Approved Section 75W Modification Application

No. MP 10-0027 MOD1 granted on the 24 JULY 2012

Revision E - Section 75W Amendments

Site 3
Sydney Olympic Park
Plan
Basement 001

**Site 3
Sydney Olympic Park
Elevation
West Elevation**

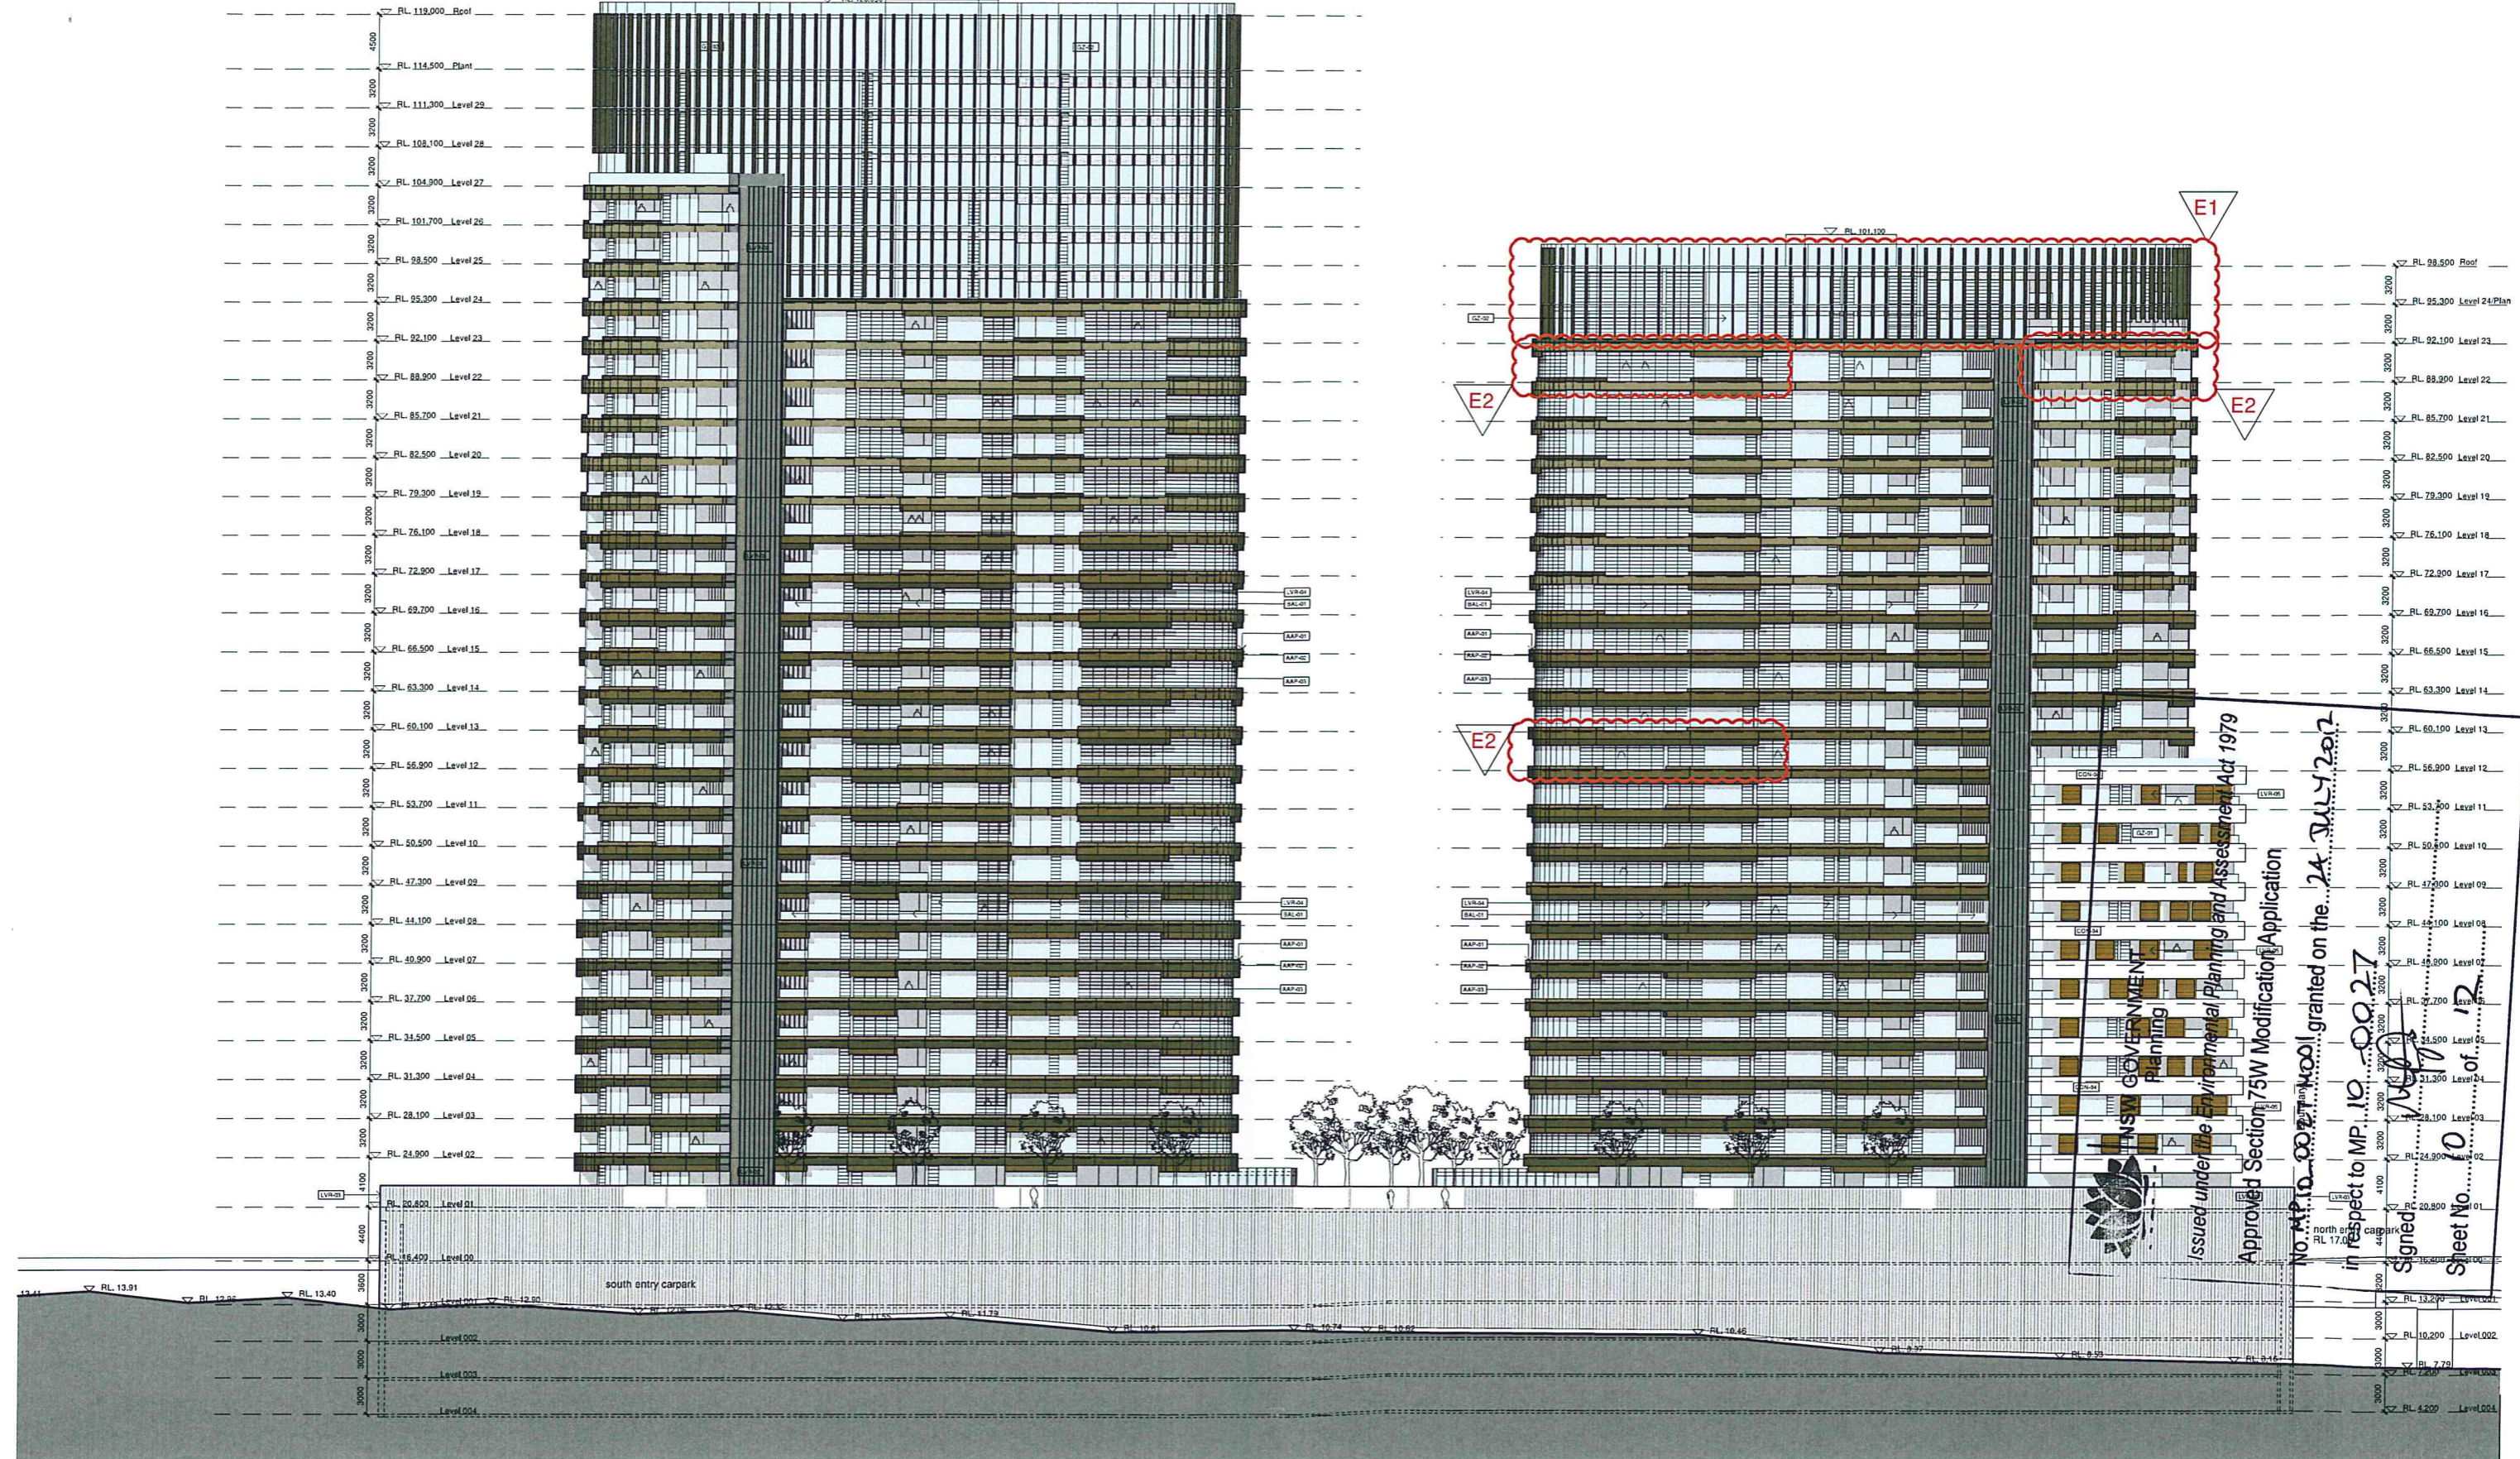
1. Left apartments modified to single storey apartments on Level 23 & 24. Elevation amended to match current plans.
2. Elevation amended to match current plans.

**Site 3
Sydney Olympic Park
Elevation
East**

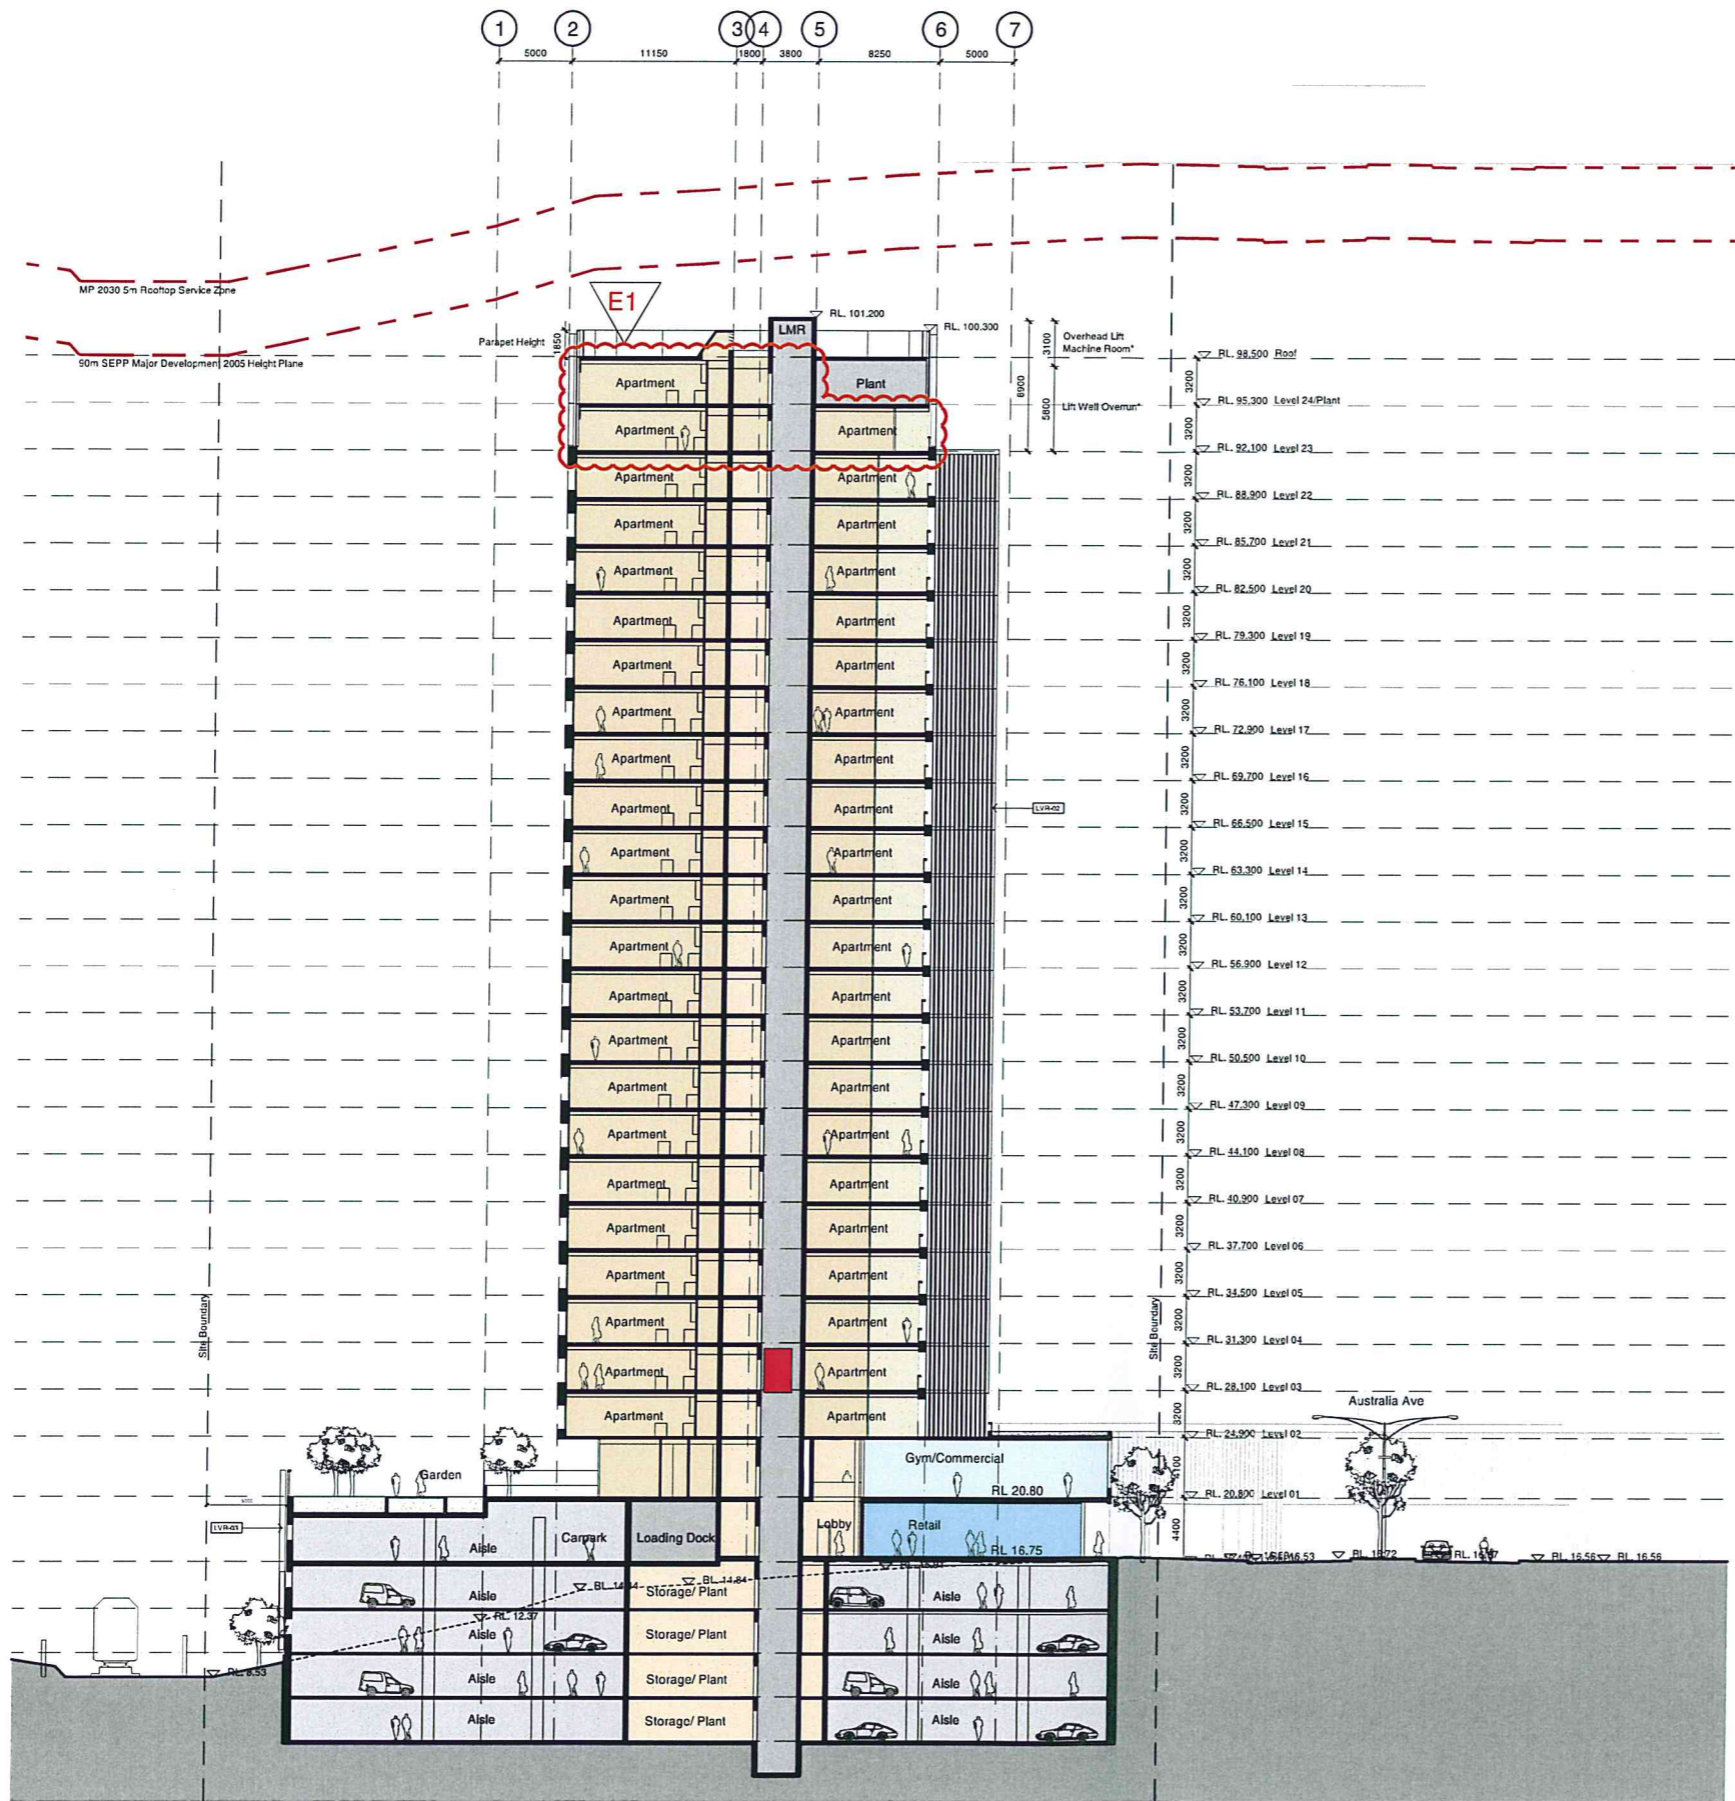
1. Lift apartments modified to single storey apartments on Level 23 & 24. Elevation amended to match current plans.
2. Elevation amended to match current plans.

Site 3
Sydney Olympic Park
Section AA

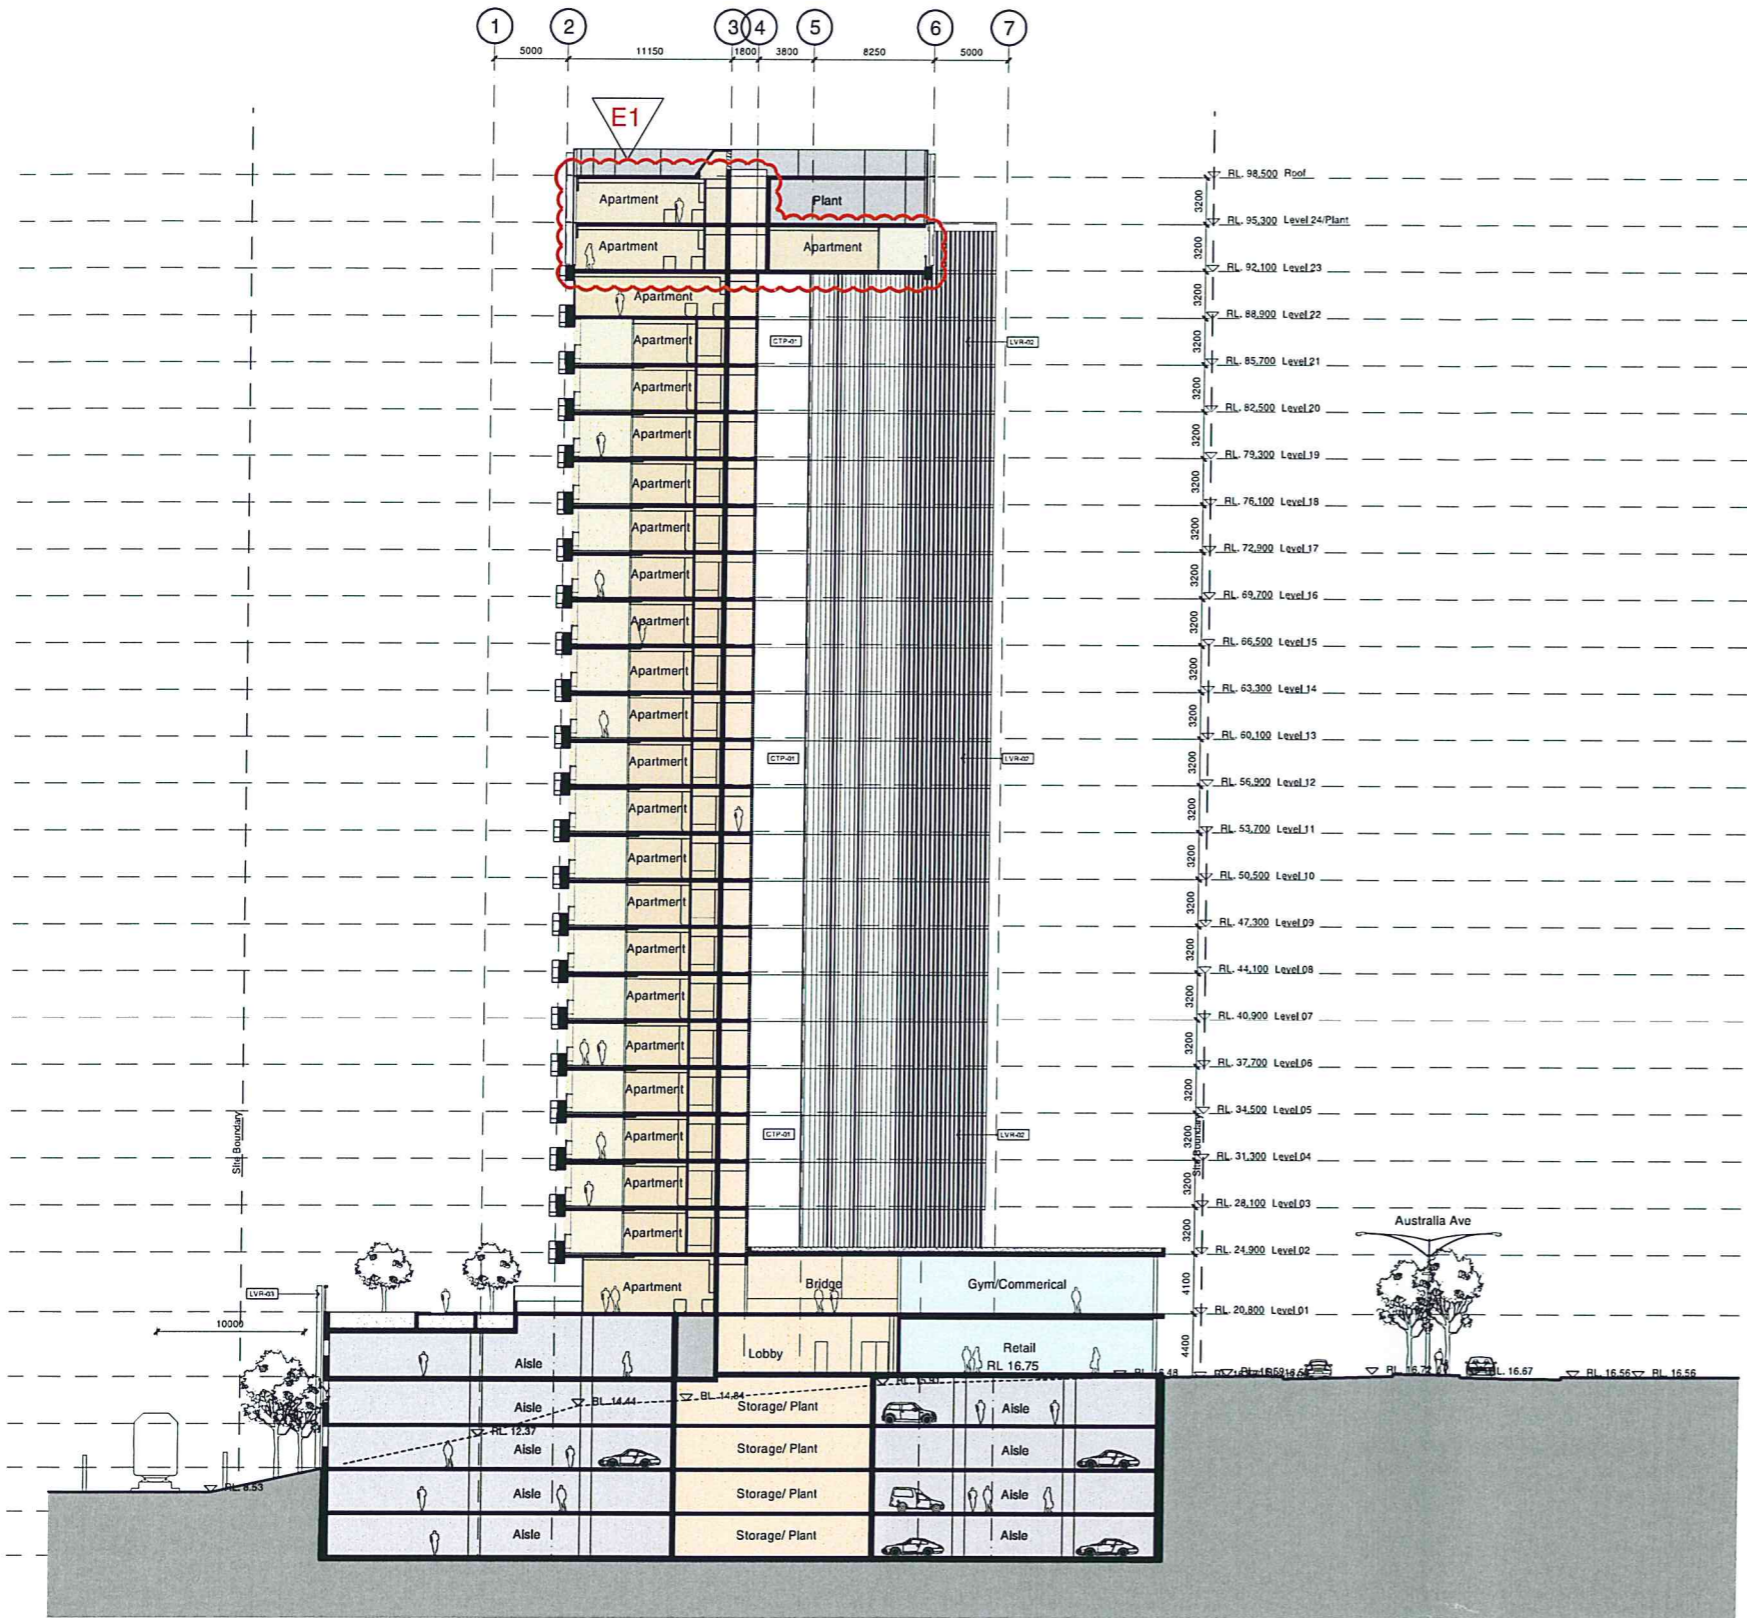
1. Lift apartments modified to single storey apartments on Level 23 & 24. Lift access has been extended to serve Level 24 apartments.
